**COWBRIDGE COMP, ABERTHIN ROAD
BATS & LIGHTING**

Further to receipt of comments from the NRW (02 March 2021), please see the Site Lighting Plan (Drawing no: 319/2/E1) and amended bat house plan (Drawing no: 3703/PA/230 Rev A). NRW raised two main queries in their response of 02 March 2021 relating to the detail of the mitigation strategy and the lighting plan.

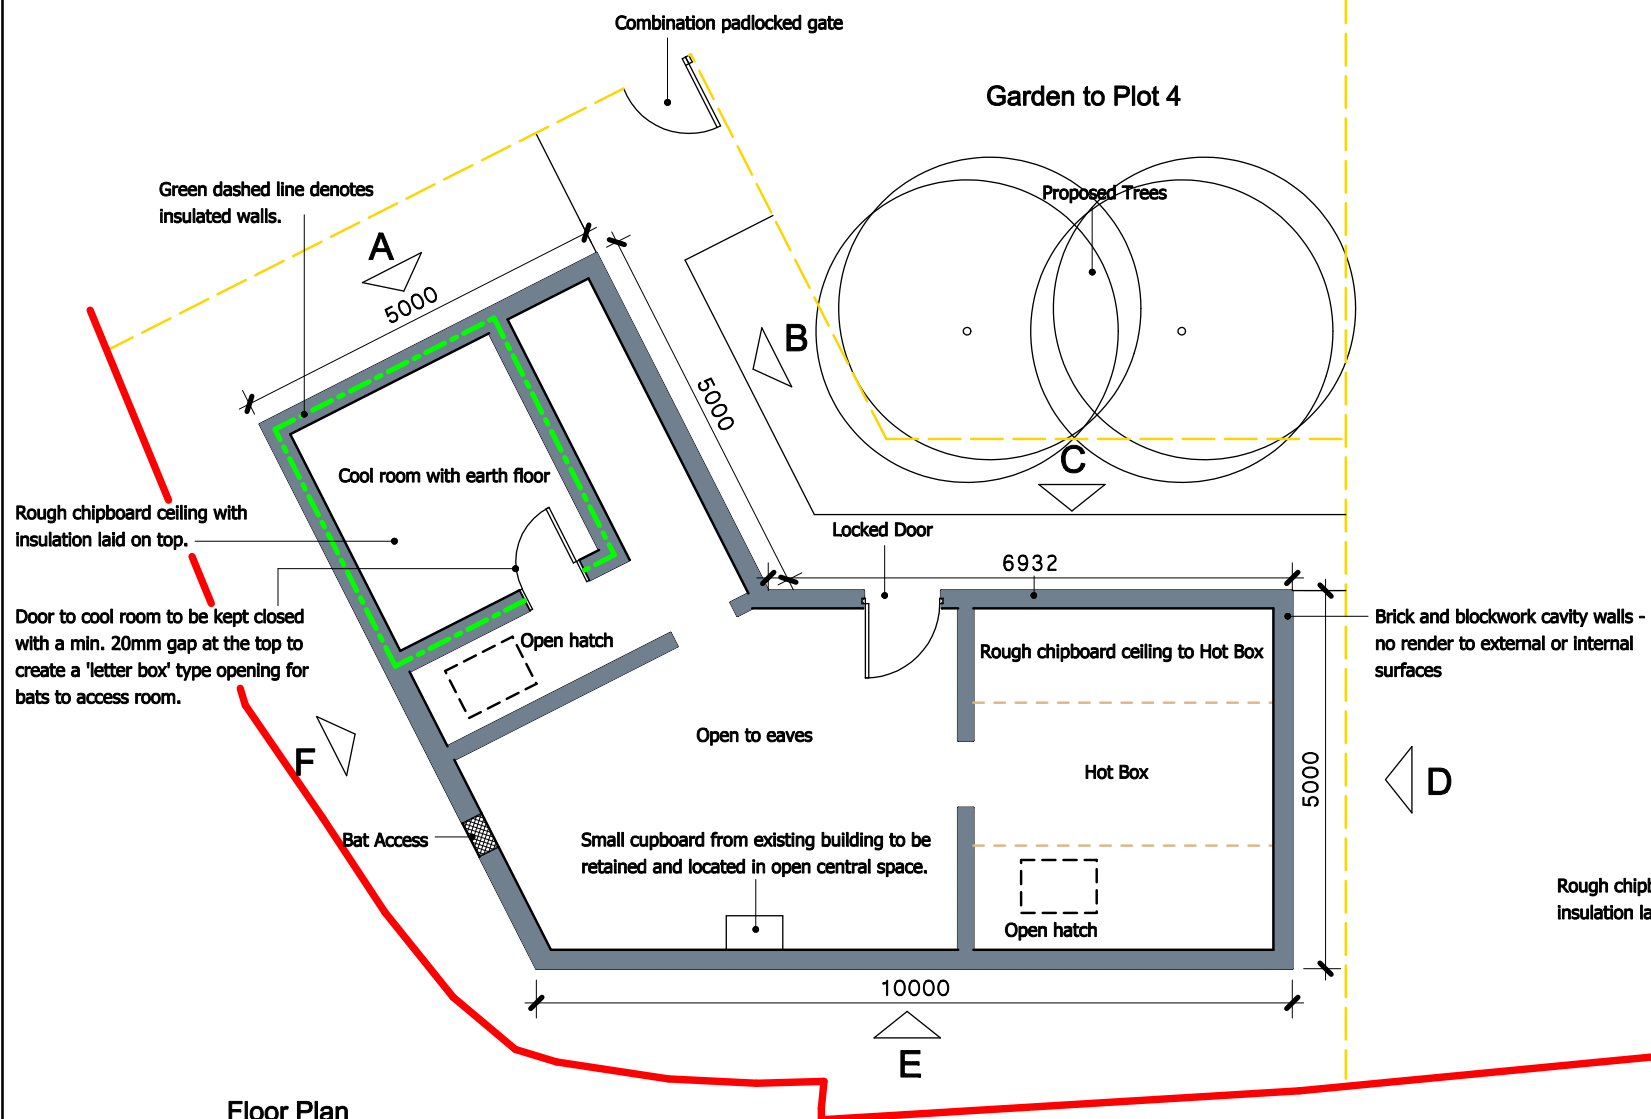
'A lighting and landscaping plan would need to be submitted with a planning application. This should look to reduce lighting over the site as a whole and avoid lighting completely in proximity to the bat house and the boundaries of the site, ensuring that a vegetated dark corridor would be maintained to the bat house which connects to the wider landscape. The plans should also include; the type of luminaire (including the exact specification), the location and height of the luminaire.'

A revised lighting plan has been produced by Tamlite Ltd. (Drawing no: 319/2/E1) to address these comments. A commitment has been made that:

- All external lights shall be 100% downward directional luminaires
- External lights to be contractor controlled as follows – western boundary to be switched off between 8pm and 6am (April to September) and dimmed to 25% (Oct to March).
- All other external lighting to be controlled via PIR and timer (set to 1min max).

With the adoption of these measures, the enclosed lighting plan demonstrates that a dark corridor can be maintained along the western boundary of the site, providing connectivity between the proposed bat house and the immediate local area. The lux plots illustrate that light reflected at ground level up to the red line boundary is around 1.0 lux, reducing further west. However it should be noted that the bollard lights are 1m high and throw light down and as such there would be virtually no lux level increase above a height of 1m. During the April – September period, these lights would be switched off and dimmed to 25% (i.e. a 75% reduction) from October to March thereby further reducing any risk of light spill and maintaining the dark corridor.

Proposed Bat Roost

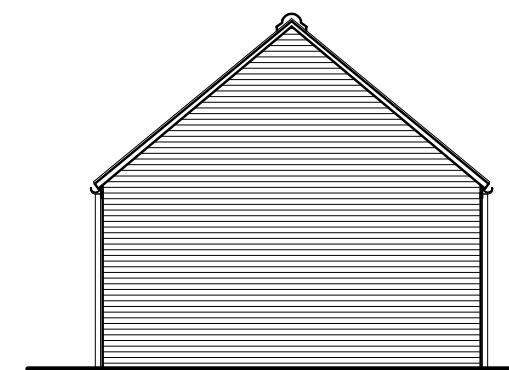
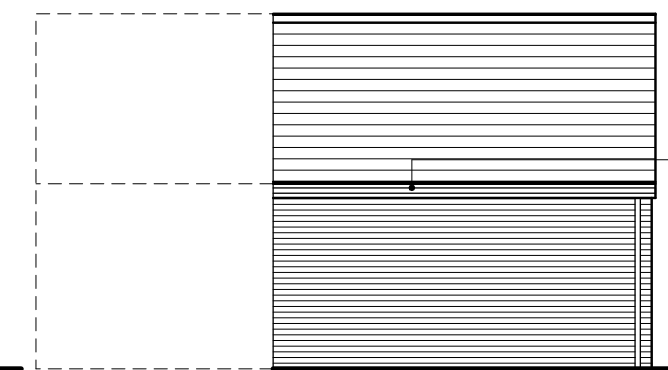
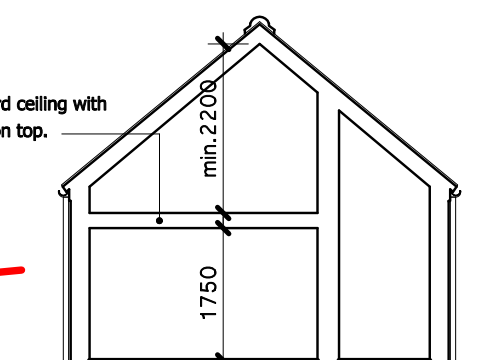
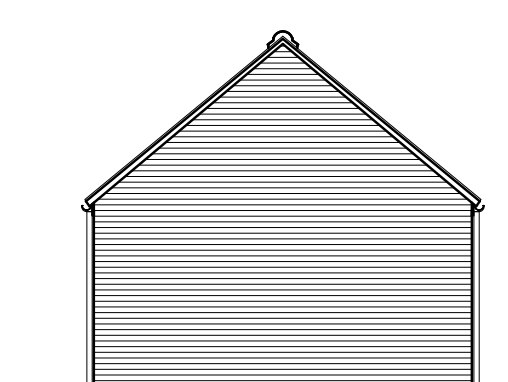
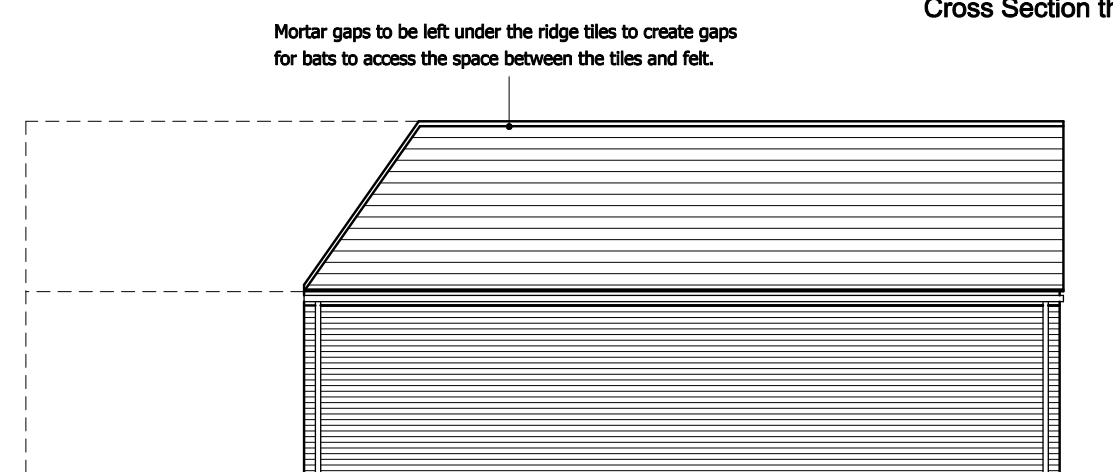
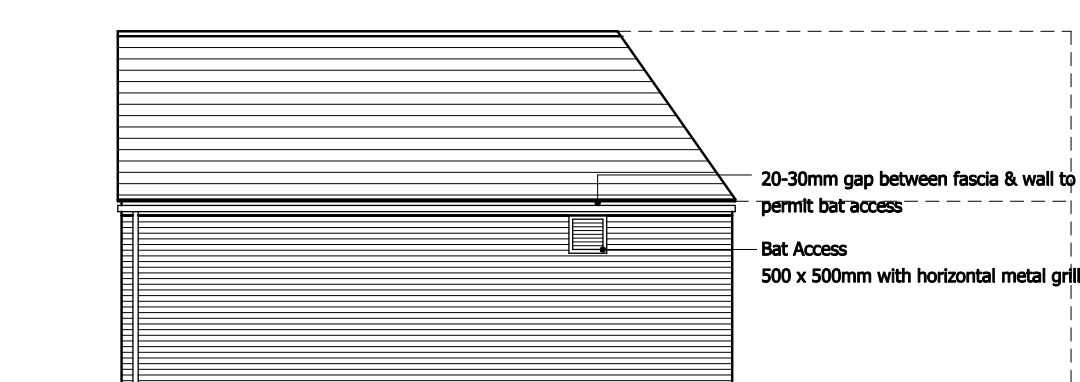
...a detailed mitigation strategy would need to be submitted upfront in support of any planning permission sought. Mitigation should be appropriate and proportionate to the bat species and roost types on site.' A detailed mitigation strategy must include;

- o Details of the permanent bat house to be provided including; all dimensions of the bat house and volume of bat roost areas, details of bat access points, materials to be used (i.e. earth floors, double skin walls), internal structure, and human access points for monitoring, how the bat house sits within the surrounding landscape.*
- o Details of provisions for the long term maintenance and site security of the permanent bat house.*

Additional detail has been added to the detailed bat house plan (Drawing no: 3703/PA/230 Rev A) specifically the internal height of the ground floor and the roof space in the bat house and whether the walls are double skinned.

A Additional notes added to plan and cross section added.
